Sandyford BD Cycle Route

Submission to Public Consultation

October 2021

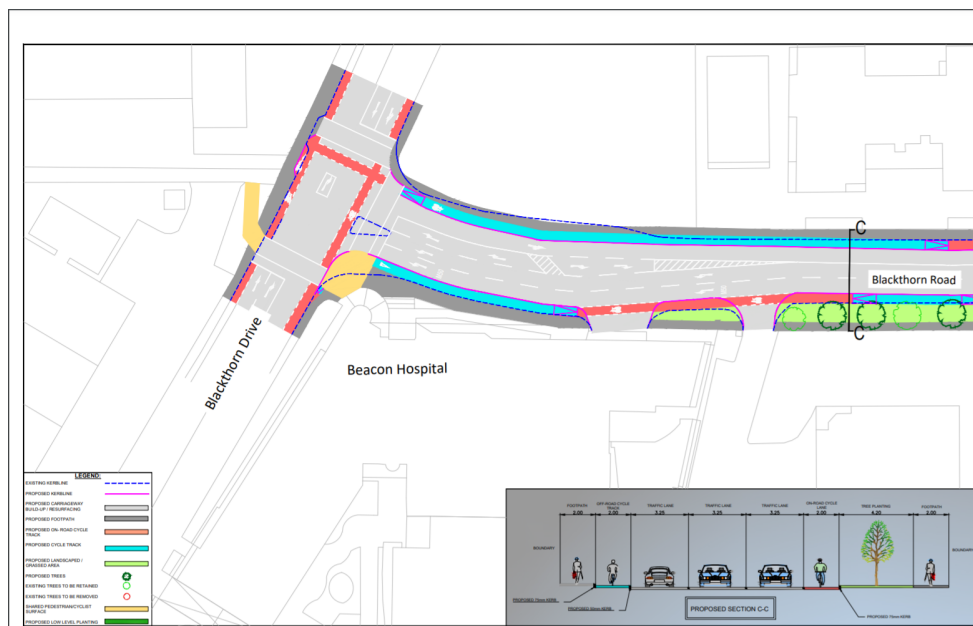
One suitable location for the Carmanhall Pocket Park could be between Raven's Rock Road and Arkle Road. Below is a very rough concept for a new pocket park right in the centre of Sandyford on Carmanhall Road.

The Carmanhall Pocket Park above would have seating and other placemaking elements to make this a destination in the centre of Sandyford BD. With much less through-traffic the area would be quieter and more pleasant. There could also be space for a small play area and exercise equipment.

Drawing 5 feedback - Blackthorn Drive & Blackthorn Road junction and approach

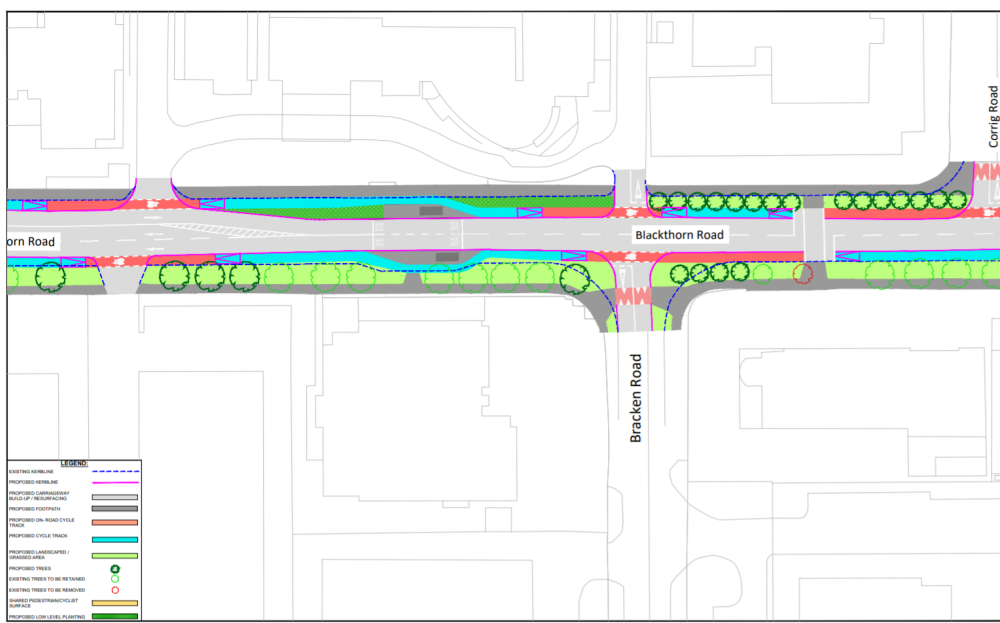
- Both options laid out for the junction here are very disappointing to see. We need to see proper protected junctions that keep pedestrians, cyclists and motor vehicles separate from each other.

- The removal of the double slip lane is definitely a positive here and will keep pedestrians and cyclists safer while providing a more straightforward crossing for pedestrians.

- The crossing is still too far for pedestrians. This is the main route for patients and staff of a hospital to access the nearest shops, car park, Luas station and public open space. A 15 metre crossing across 4 traffic lanes, one cycle track that is shared with cyclists on one side of the road is not a high level of provision for pedestrians. It also requires a longer pedestrian crossing time and makes it more difficult to cross completely across both roads in one crossing.

- The lack of protection at side roads here is dangerous for cyclists. Cycle tracks should remain raised across minor roads and private entrances.
- The existing illegal parking in front of the shops will not stop with this design as these low kerbs are easy to mount. The parking enforcement regime in DLR is years away from being able to keep cycle lanes like this clear at most times.

- The provision of 2 stacking lanes for turning left reduces available space for pedestrians and cyclists, retains a high traffic capacity inducing demand for private car traffic and makes for a more hostile, car-dominated environment in front of the hospital and the shops.

- There should be only one left turning lane heading towards Drummartin Link Road. One should be removed in order to narrow the road width. Retaining the 2nd left-turning lane increases the crossing width for pedestrians crossing the road. Pedestrian and cyclist concerns here should be placed at a higher priority than “traffic capacity” of the junction which is clearly the reason for retaining the lanes.
- There should be a protected junction here, not a junction where pedestrians including hospital patients are expected to share space with a high volume of commuter cyclists. This is already a busy pedestrian crossing and will get busier with increased development in the area. The designers should consider the junction design being trialled by DLR engineers at the nearby Eden Park junction (Active School Travel project).

- The cycle tracks here need to be vertically and horizontally segregated from motor traffic. This could be by planters or raised grass buffers. This is the only way to prevent the persistent illegal parking here. Examples given under General Feedback above of how this small 50mm kerb does not address this issue.
- The right turn filter into the Beacon car park is an unnecessary luxury for the convenience of a small number of drivers. There are roughly 300 car parking spaces under the Beacon. It should be removed in order to narrow the road width and allocate space to segregating the cycle track in such a way that drivers cannot drive or park on it. Additionally, planning permission granted under application 09A/0175 required the Beacon Hospital to install bollards to prevent drivers making right turn movements into and out of the car park from Blackthorn Road.

Drawing 6 feedback - Blackthorn Road and Bracken Road

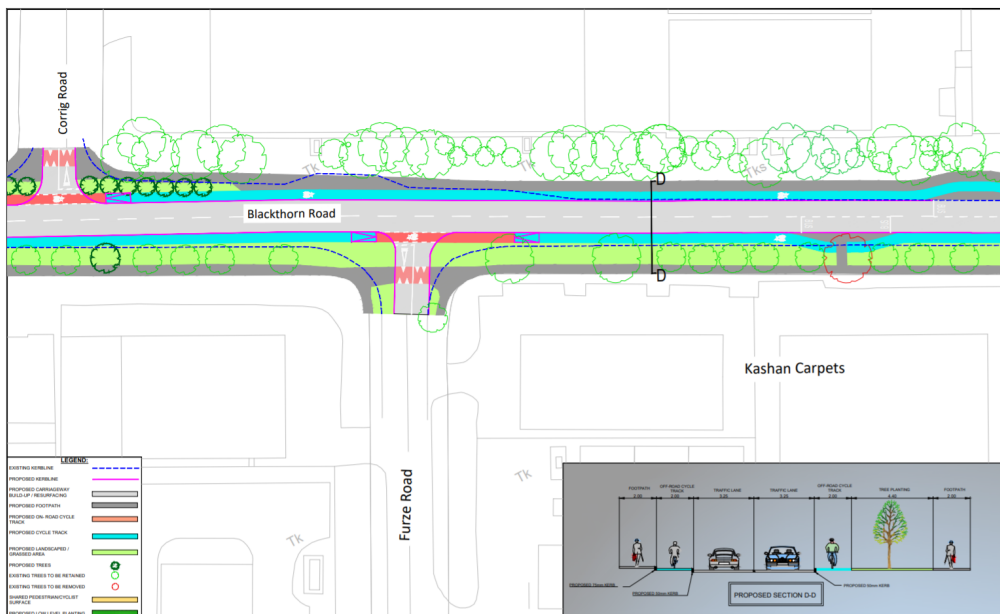
- Many of the general issues raised above apply here too including the poor treatment of walking and cycling at side roads. In particular, the continuous footpaths and cycle tracks should not be interrupted in level by the entrances to car parks.

- The cycle lane appears to narrow when 2 lanes are introduced approaching Blackthorn Drive. These 2 lanes should not start until after the 2 car park entrances to the left of Drawing 6.

- The location of the crossing isn't helpful for cyclists looking to turn right at Bracken Road coming from either direction. The crossing should be right next to the Bracken Road junction with a "sparrow crossing" where cyclists and pedestrians have separated spaces to cross but share lights. There should be a dedicated space for cyclists to wait that is not pedestrian space.

- A positive here is that trees are being retained and new trees are being planted.
- A positive here is the cycle track continuing around the back of the bus stops.

- The location of the bus stops are hard to understand. They should be close to the nearby pedestrian crossing. The current desire line will see pedestrians crossing the road without using the crossing as most demand for the bus is coming from the other direction (Beacon Hospital and Beacon South Quarter). The solution would be to move the crossing beside Bracken Road on the same side as the bus stops.

Drawing 7 feedback - Blackthorn Road and Furze Road

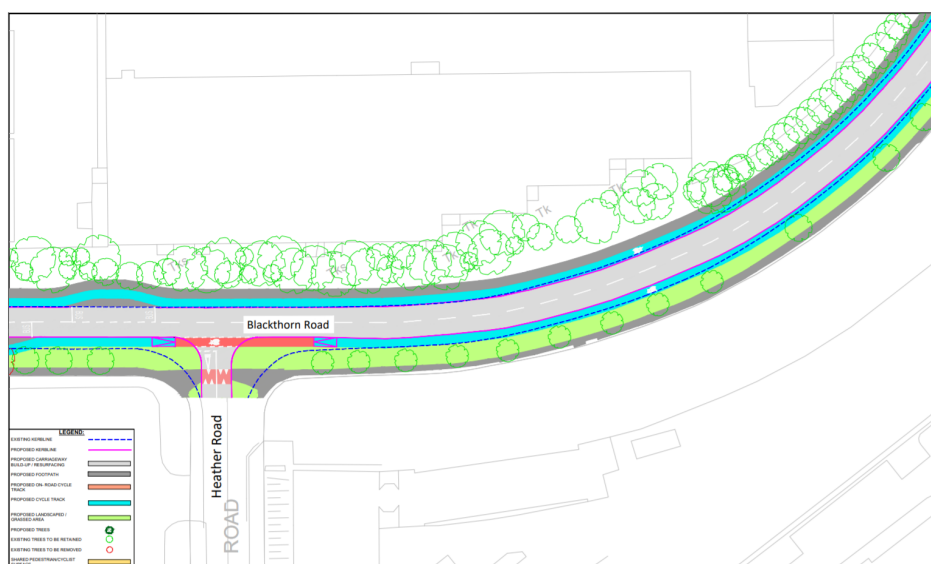
The only new piece of feedback here is regarding the side roads which is already raised above.

Drawing 8 - Blackthorn Road and Heather Road

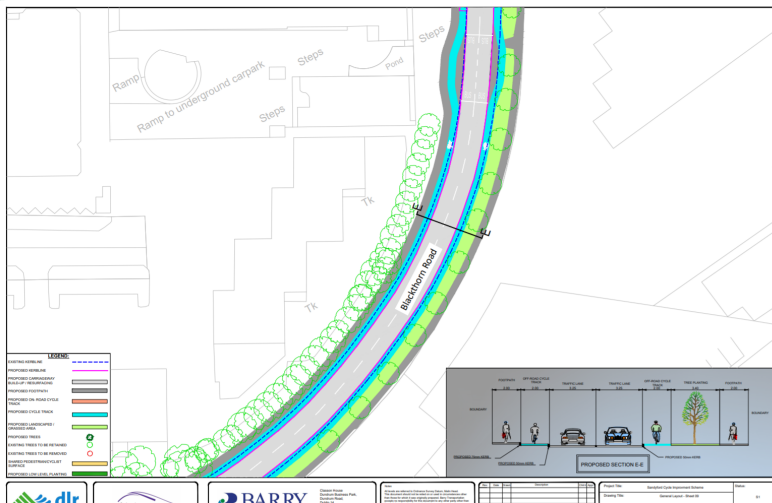
- Same as Drawing 7: side road treatment should be a continuous cycle track.
- This may be the location where the new ESB Link Road meets Blackthorn Road and should have been shown as part of the designs that are out to public consultation. This junction should be designed as a protected junction, or at least presented as one of the options.

Drawing 9 feedback - Blackthorn Road

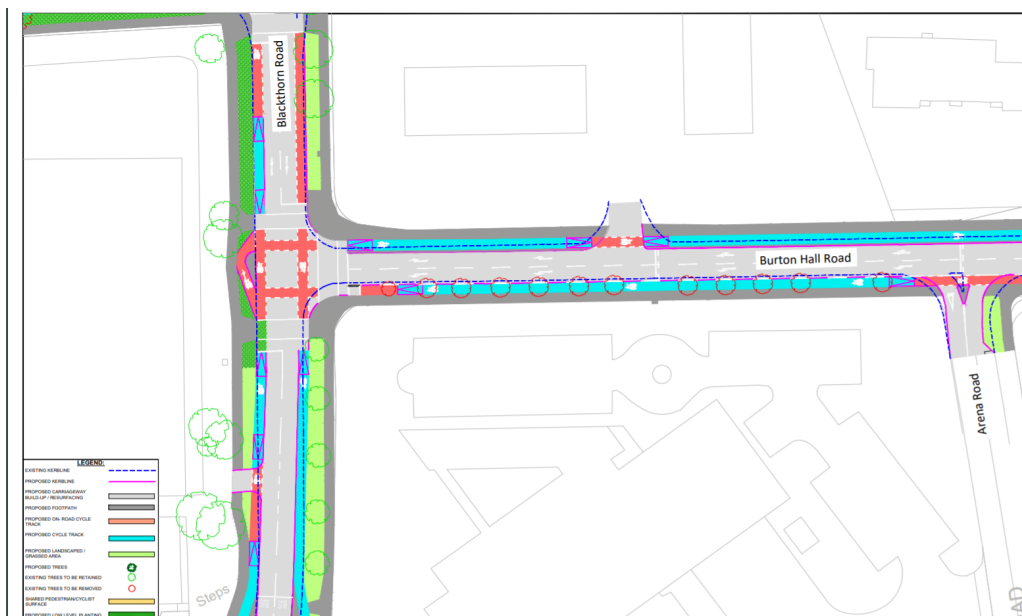
As there is currently no parking or unloading demand on this section of road, the 50mm kerb is acceptable. It is positive to see that the carriageway will be narrowed and trees retained.

Drawing 10 - Blackthorn Road junction with Burton Hall Road

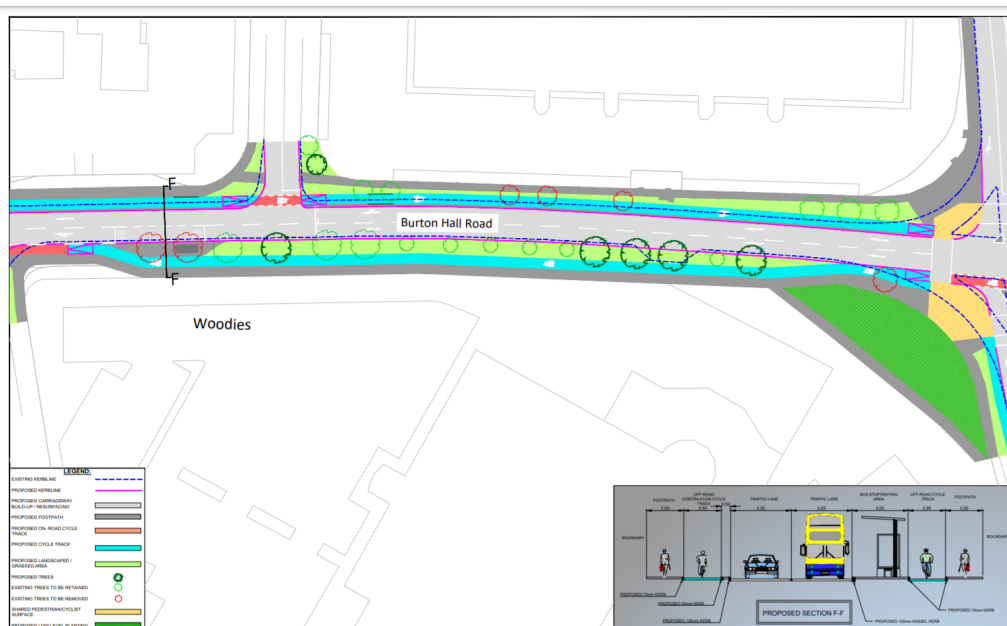
- The crossings here would be a good upgrade for pedestrians with the extra crossing across Blackthorn Road. The lights should go green for pedestrians all at once here.

- It is disappointing to see the junction between Blackthorn Road and Burton Hall Road designed so as to give no protection to cyclists moving through the junction. This is an opportunity for a fully protected junction.

- A fully protected junction would allow cyclists to make additional movements when lights are red for their arm of the junction: Straight on Blackthorn Road towards Carmanhall Road, left from Blackthorn Road onto Burton Hall Road, left from Burton Hall Road onto Blackthorn Road.

- Removing 12 trees here is completely avoidable. There is a need to reduce traffic volumes and increase tree cover in Sandyford BD. This proposal to retain 2 lanes of traffic the whole length of Burton Hall Road goes against that. Retaining 2 lanes of traffic here will encourage higher speeds off-peak and be just as congested during peak as if a lane were to be removed. We must take brave decisions and have confidence in modal shift leading to a reduction in traffic volumes.

- The side road entrance into Arena Road still appears to be a high speed turn due to the kerb radii. This should be narrowed and straightened and a raised crossing provided for pedestrians. The proposed retention of a middle island at a side road crossing just encourages high speed turns from motorists and de-emphasises pedestrian priority.

- The entrance/exit into/from Sandyford Business Centre should be closed off to vehicular traffic as it prevents a safety hazard for cyclists travelling contra-flow as is one more unnecessary side road for pedestrians to cross. Sandyford Business Centre already has access/egress on Blackthorn Road. The property owner could be compensated somewhat but this should be minor in the overall scheme of the project.

Drawing 12 - Burton Hall Road/Blackthorn Avenue junction

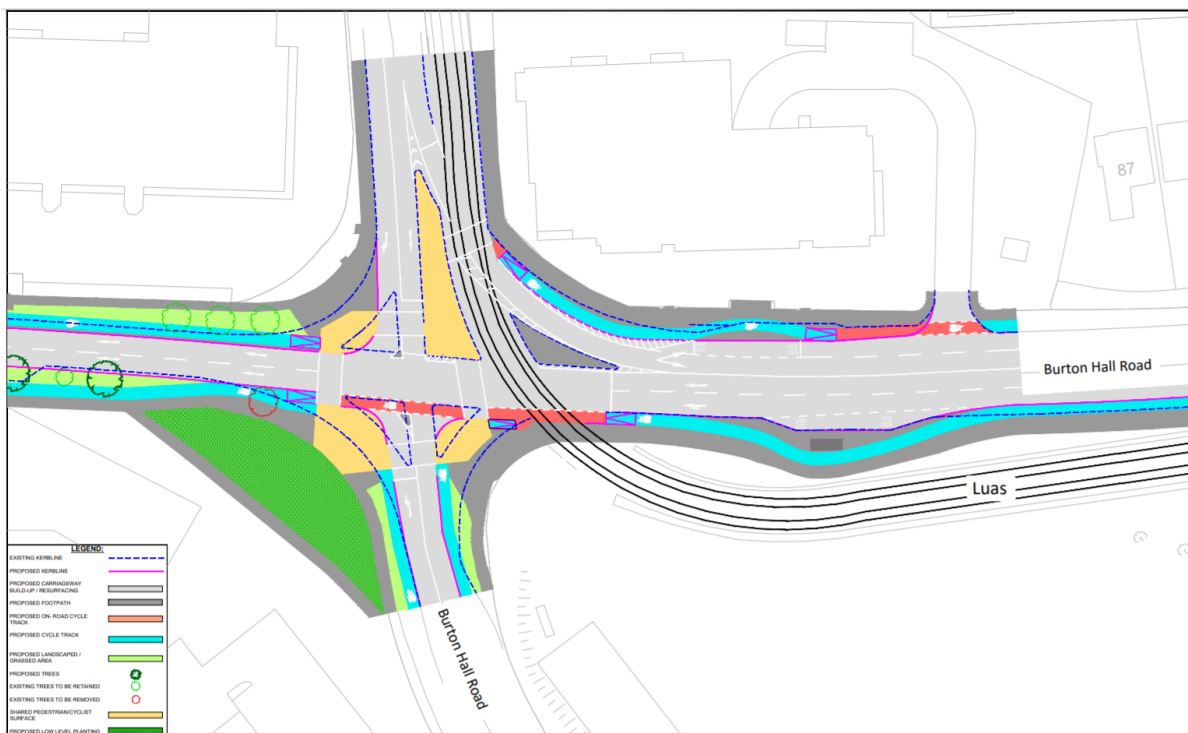
I utterly reject the suggestion in the report that there are insurmountable constraints at this junction. The constraints are completely self-imposed by the planning/design decision to start with maximum motorist convenience and then fit everything else around that.

- This proposed junction design overall is safer than the current junction layout but still falls well short of what should be aspired to in 2021. The clear emphasis is on traffic volumes and capacity rather than road safety, modal shift, public transport or pollution reduction. The aspiration should be for a much more compact junction that offers protection to cyclists, shorter crossing distances for pedestrians and real priority given to public transport.
- Requiring some cyclists to use 3 crossing points shared with pedestrians to make a right-turning movement is completely unacceptable, increasing cyclist journey times and increasing the conflict between pedestrians and cyclists. Cyclists using the new contra-flow on Burton Hall Road and continuing straight will take a completely

- Ending cycle tracks on shared spaces is an anti-pedestrian and anti-cycling design feature. It has been advocated against by cycling groups and disability groups and should be discarded here.

- The junction should be changed to be a fully protected junction. Any left-turning traffic should be held on a red while cyclists and general traffic continue straight-ahead through the junction. Left-turning cyclists should have a “free left” at all arms of the junction, just yielding to crossing pedestrians.

- The large left-turn slip lane from Blackthorn Avenue to Burton Hall Rd should be removed. Instead, turn the proposed large traffic island into a short left turn lane. The removal of the slip lane will remove the major conflict point that currently exists between the Luas and car drivers. With 55m trams running at 4 minutes headway, the slip lane is actually completely useless in terms of traffic capacity anyway. The junction should not interact with the tracks whatsoever.

- In order to facilitate the extension of the cycle track along Blackthorn Avenue and the removal of the large left-slip turn along the Luas tracks, there should be a reduction to 2 general traffic lanes on Blackthorn Avenue. Cycle lane should continue straight from Blackthorn Avenue instead of mixing with pedestrians after crossing the Luas tracks. This will enable it to tie in better with the reconfiguration of the Burton Hall Road junction that I am proposing. The arrangement below on Blackthorn Avenue is a deprioritisation of cycling:
